**HUDDERSFIELD**

**DESIGN & ACCESS  
STATEMENT ADDENDUM**

Design & Access Statement Addendum

Document No:	IR430301-CTA-XX-XX-RP-A-019200
Revision No:	01
Date:	26.01.2023
Authored by:	HM
Checked by:	JF

Original Approved Scheme - Internal Screen Elevation

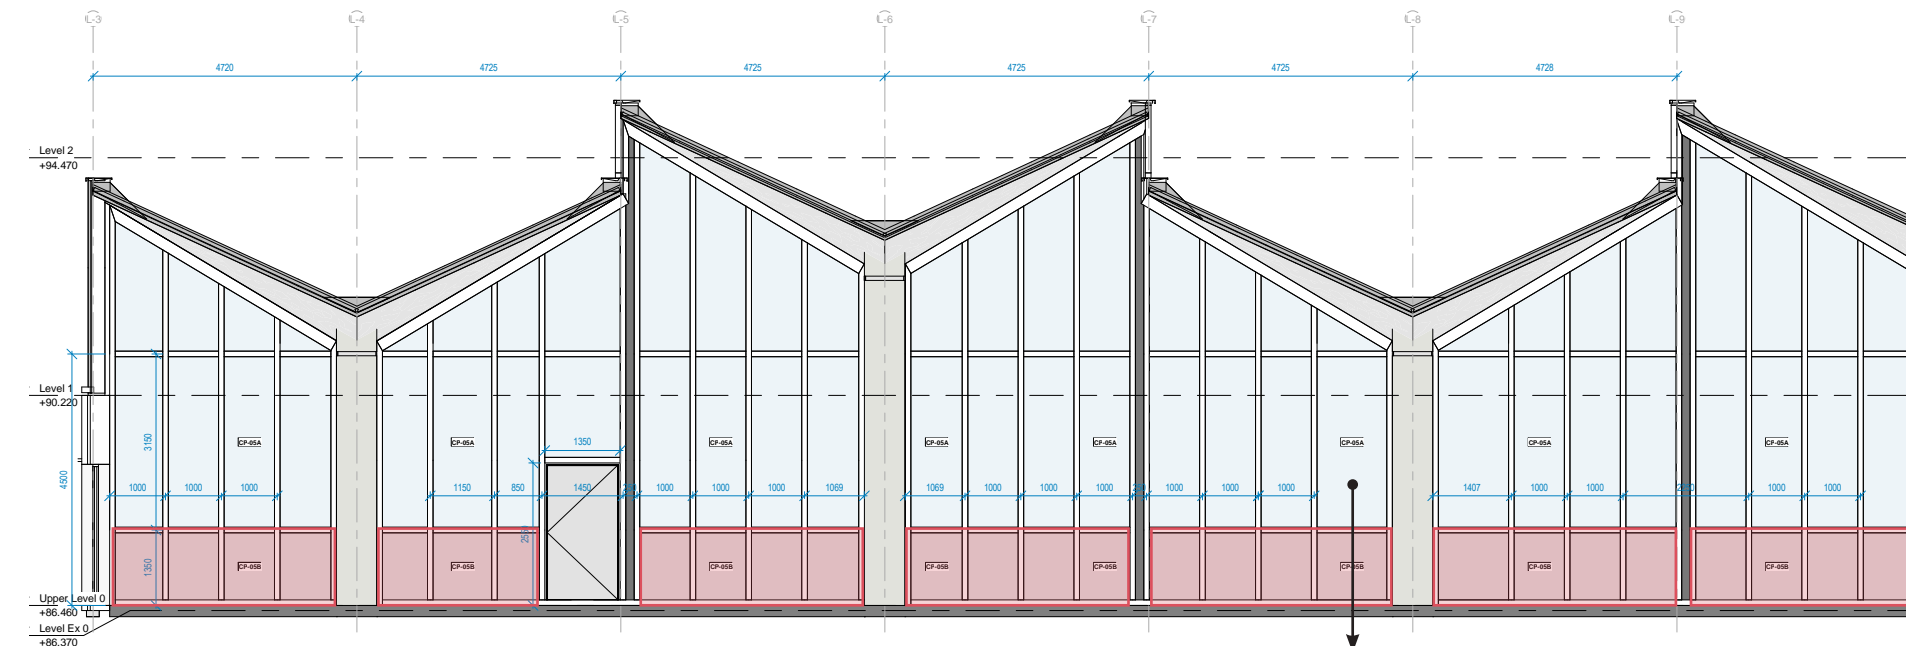
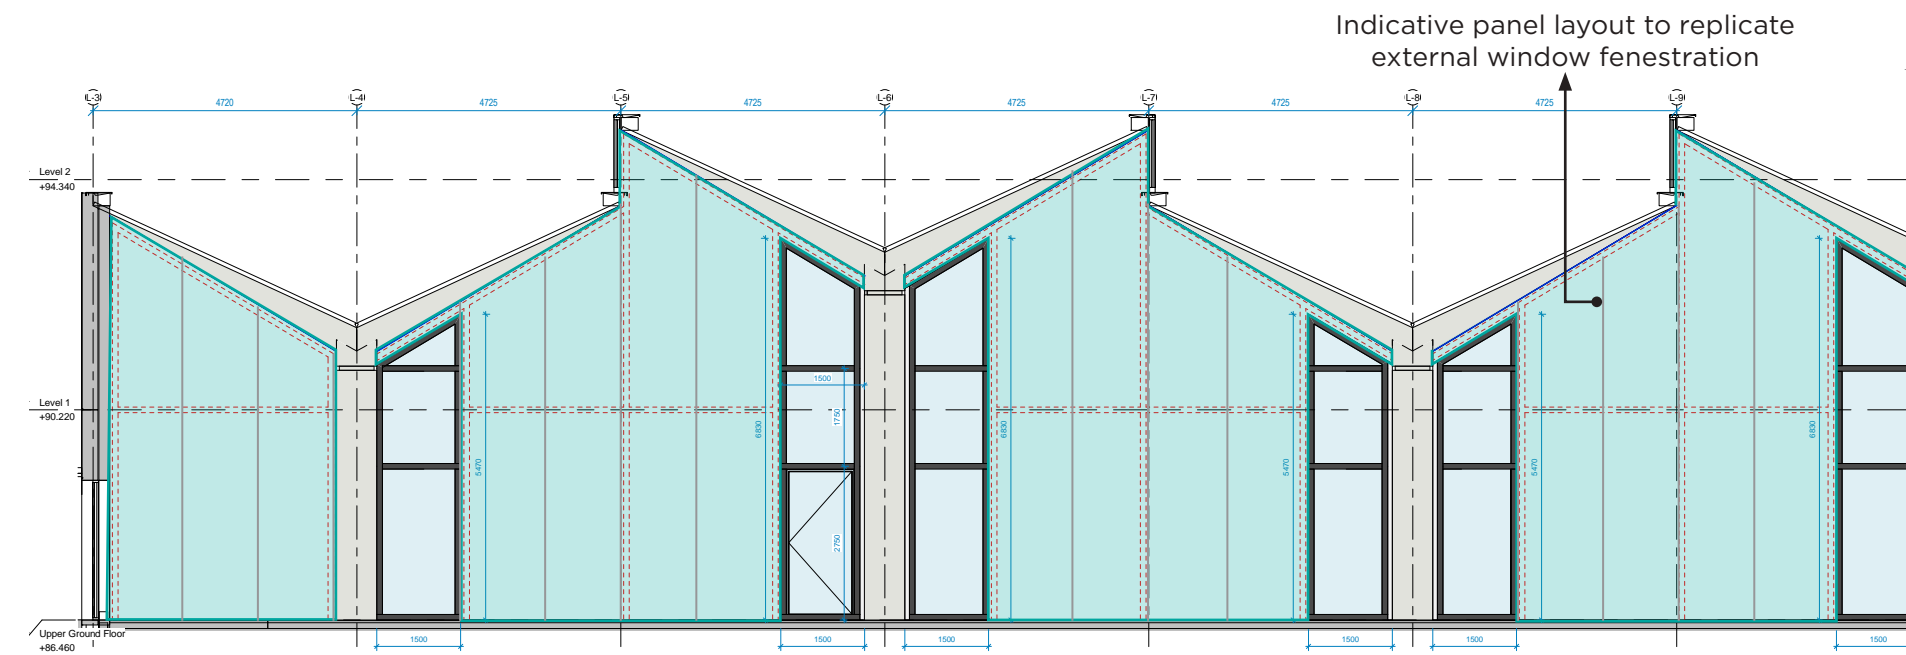
The deviation from a fully glazed separating wall approach between the Food Hall and the Library was noted earlier in this document. A full height, fire rated, glazed screen was proposed in the original approved scheme, however further review presented the following technical issues:

- Limited suppliers of fire rated curtain wall systems to provide the fully glazed approach.
- Lack of fire test certification for junction detail where curtain wall system abuts the concrete soffits.

To alleviate these technical issues, the amended proposals include for solid fire rated construction with fire rated window systems integrated to achieve the desired visual connectivity between the spaces. A pair of vertical windows is proposed to either side of the existing columns to frame views of the existing roof structure and emphasize the height of the space. These pairs of windows to be introduced across the width of the separating wall to capture multiple aspects. The introduction of a fire rated window approach provides a number of available solutions and avoids fire test certification issues by removing the direct interface detail with the existing concrete soffit.

In response to the vertical nature of the space, and its external glazing fenestration, the window form and approach of the panelling of the separating wall aim to enhance the verticality.

Following discussions with the Conservation Officer (refer Section 3.3) the width of the fire rated windows was increased to improve views from the Library into the Food Hall.

West Elevation Bay - Proposed Amended Design

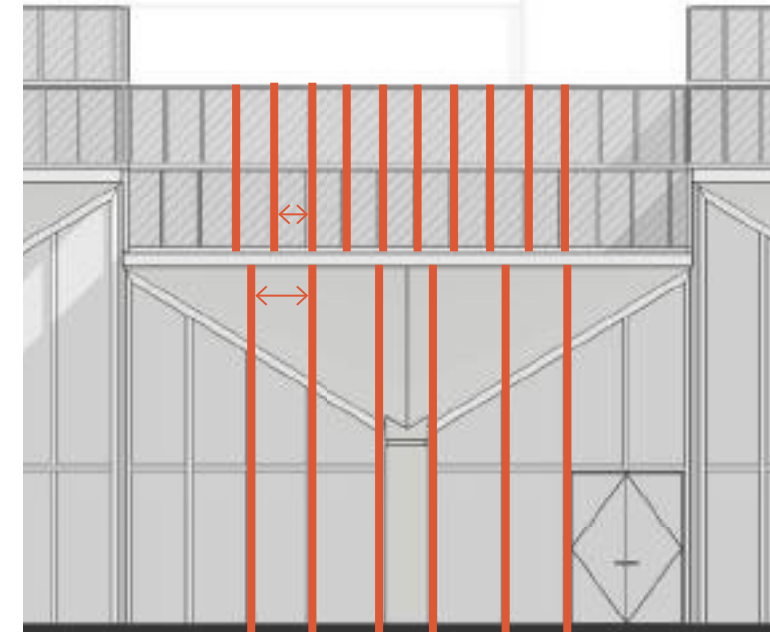
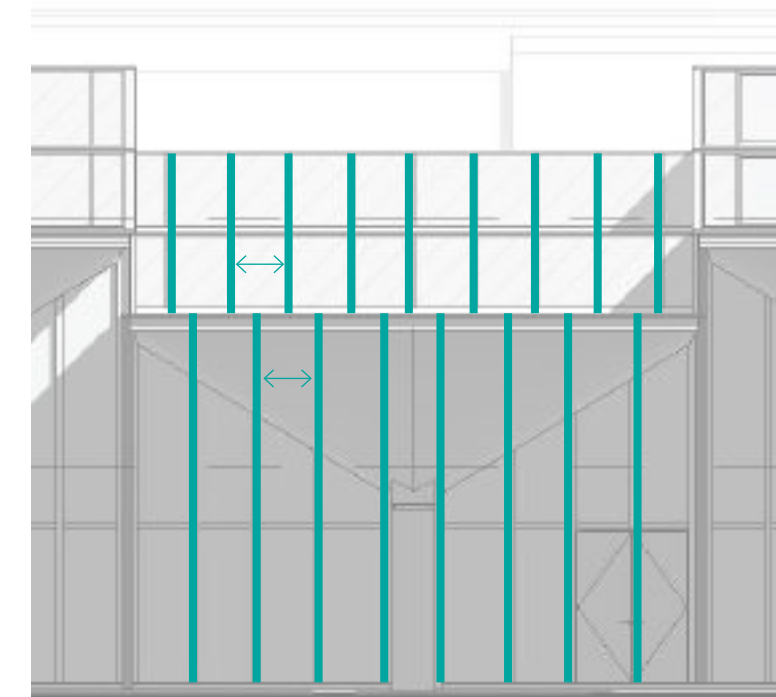
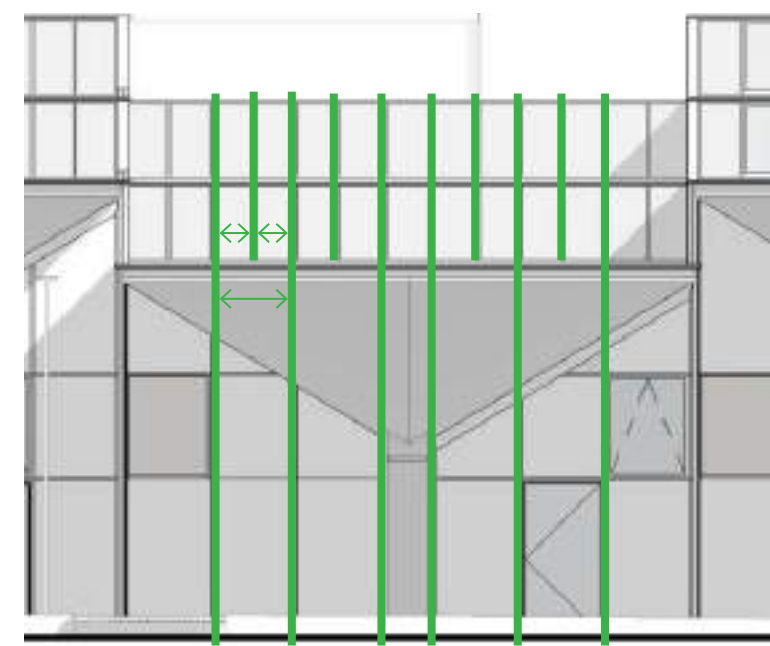
One of the main changes to the Food Hall elevations is the width of the curtain wall glazing panels and how they relate to the upper level clerestory glazing.

Comparison studies were undertaken between the existing widths and the original approved scheme in the development of the revised widths. These studies and the proposed amendments were one of the key topics discussed with the Conservation Officer (refer Section 3.3).

The Project Team wanted to re-establish more of the continuity seen in the existing elevation when considering the glazing widths. Conscious of the increased thickness of modern curtain wall system against the original framing and that close centres could leave a 'chunky' appearance, early development lead to widening the clerestory glazing to match the lower level panel widths.

Following further consultation with the Conservation Officer, and to address concerns on square appearance of the clerestory glazing, the proposals were further developed to marginally increase the clerestory to retain rectangular/vertical proportions. Continuity is provided to the lower section by aligning alternate mullions.

Sample slides from 13.11.23 Meeting

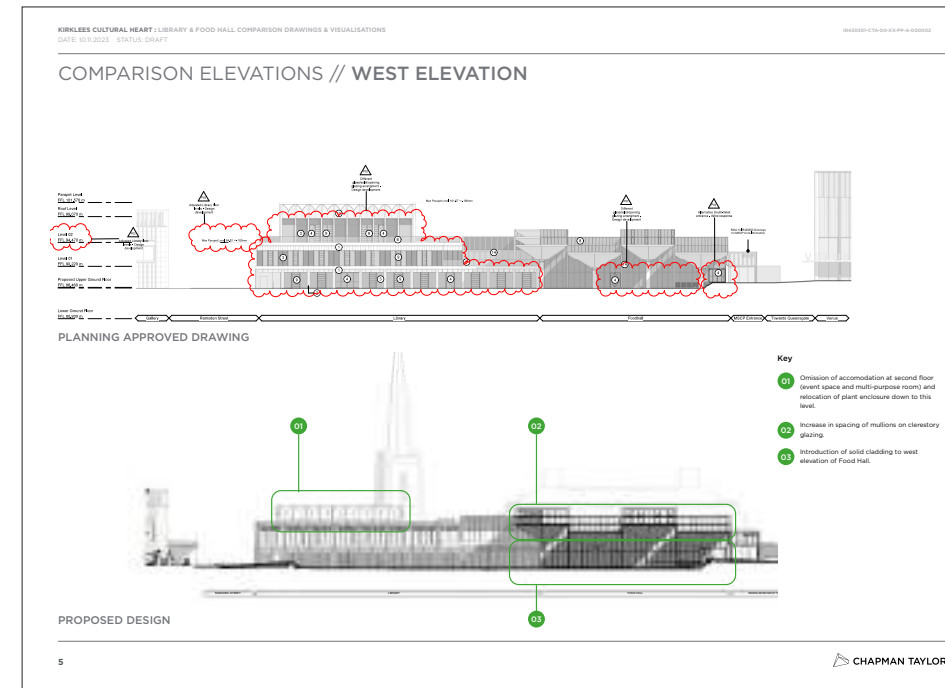
#### Item 01: Clerestory windows

Amendment:

Increase the spacing of mullions on the clerestory glazing by around 300mm to regularise this across the building - more consistent internally with very little impact externally.

*"I don't feel that there is any justification for this as the existing pane sizes are faithful to the original. When viewed from inside the building the pattern of these windows with their vertical emphasis and the perspective through the hall is interesting. Instead of changing the existing windows to replicate the new interventions, I would suggest that the new windows are designed to complement the existing."*

#### Item 02: Library/Food Hall Separating Screen

Amendment:

Instead of full height glazing between the library and market hall, a solid wall (1hr fire screen) is proposed with narrow vertical windows.

*"The current view across the inside of the market hall from the first-floor offices is panoramic and shows off the impressive architecture of the shell structures from an interesting viewpoint which the public haven't previously been able to appreciate."*

*Installing a solid screen with limited narrow glazing will almost completely lose this impressive view, particularly as the library is separated from the narrow windows by a stairwell and atrium. This needs further investigation, and I would suggest that extensive fire rated glazing is retained in this area to maintain the view of the food hall. As a compromise could the glazing extend across the central bay (with careful detailing and expansion joints at high level) where the view would be appreciated from the top of the stairs, with solid screens and narrow windows in the side bays?"*

Action: Chapman Taylor to investigate this further.

Action: Chapman Taylor to investigate this further.
